Richmar Unit 4 Replat A

City Plan Commission — March 27, 2025

CASE NUMBER/TYPE:	SUSU25-00023 – Resubdivision Combination
CASE MANAGER:	Myrna Aguilar, (915) 212-1584, AguilarMP@elpasotexas.gov
PROPERTY OWNER:	Anne Brock and John Russell Kocian
REPRESENTATIVE:	Conde, Inc.
LOCATION:	West of Cotton St. and North of Murchison Dr. (District 8)
PROPERTY AREA:	1.18 acres
VESTED RIGHTS STATUS:	Not Vested
PARK FEES:	\$5,480.00
EXCEPTIONS/MODIFICATIONS:	Yes, see following section
ZONING DISTRICT(S):	R-4 (Residential)
PUBLIC INPUT:	1 email in opposition received as of March 18, 2025

SUMMARY OF RECOMMENDATION: Staff recommends **APPROVAL** of Richmar Unit 4 Replat "A" on a Resubdivision Combination basis.

REQUIRED CROSS-SECTION:

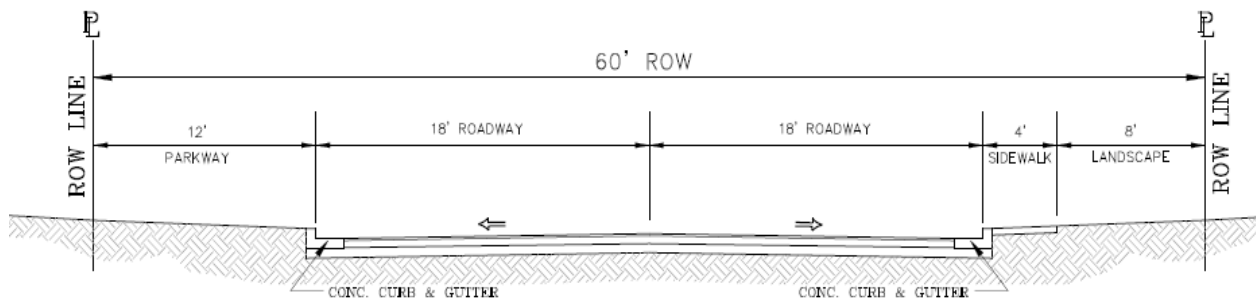
1. To waive the construction of one foot (1') of sidewalk and to allow the sidewalk to abut the roadway along Rocky Bluff Road.

EVALUATION OF EXCEPTION REQUEST: The exception request to waive right-of-way improvements meets the following criteria under El Paso City Code 19.10.050(A)(1)(a) – (Roadway Participation Policies—Improvement of Roads and Utilities Within and or Abutting the Subdivision). The section reads as follows:

RICHMAR UNIT 4

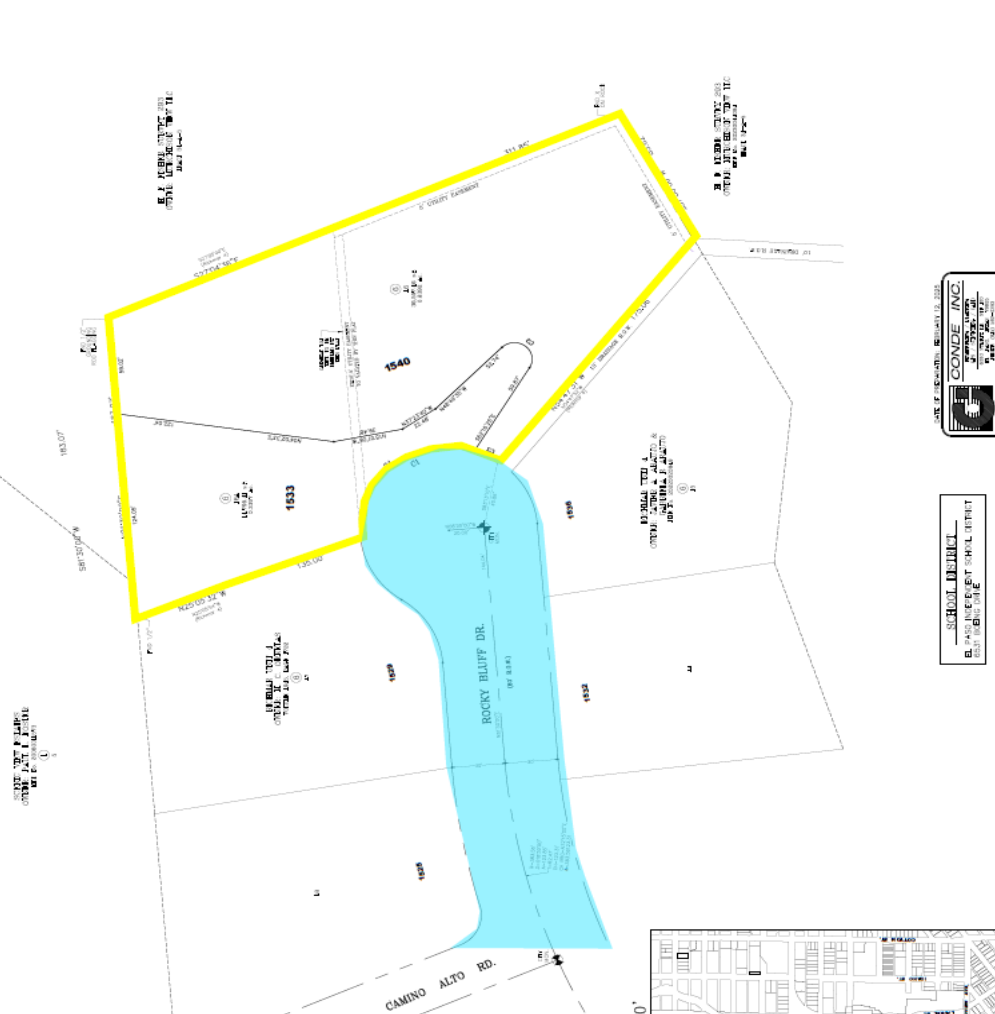
1. Submit to the Planning & Inspections Department – Planning Division the following prior to recording of the subdivision:
 - a. Current certificate tax certificate(s)
 - b. Current proof of ownership.
 - c. Release of access document, if applicable.
 - d. Set of restrictive covenants, if applicable.
2. Every subdivision shall provide for postal delivery service. The subdivider shall coordinate the installation and construction with the United States Postal Service in determining the type of delivery service for the proposed subdivision. In all cases, the type and location of delivery service shall be subject to the approval of the United States Postal Service.
3. **Provided warranty deed does not provide both listed owners. Please provide correct warranty deed.**
4. **Remove quotation marks prior to printing mylars.**

1. Provide print-out of the mathematical closure of the exterior boundary of the subdivision indicating the error of closure, for the entire continuous perimeter.

1. Provide a conceptual Drainage Plan indicating existing and proposed major stormwater facilities as per Section 19.02.020 of the Municipal Code.
2. At the improvement plan stage, provide protection to the subdivision from all offsite storm water runoff that may have an adverse impact on any improvements and convey the existing watercourse through the subdivision.
3. As per the Municipal Code: new developments and redevelopments are required to maintain the pre-development hydrologic response in their post-development state as nearly as practicable to reduce flooding. The code also encourages the use of nonstructural storm water management such as the preservation of green space, water harvesting, and other conservation efforts, to the maximum extent practicable, per Section 19.19.010.
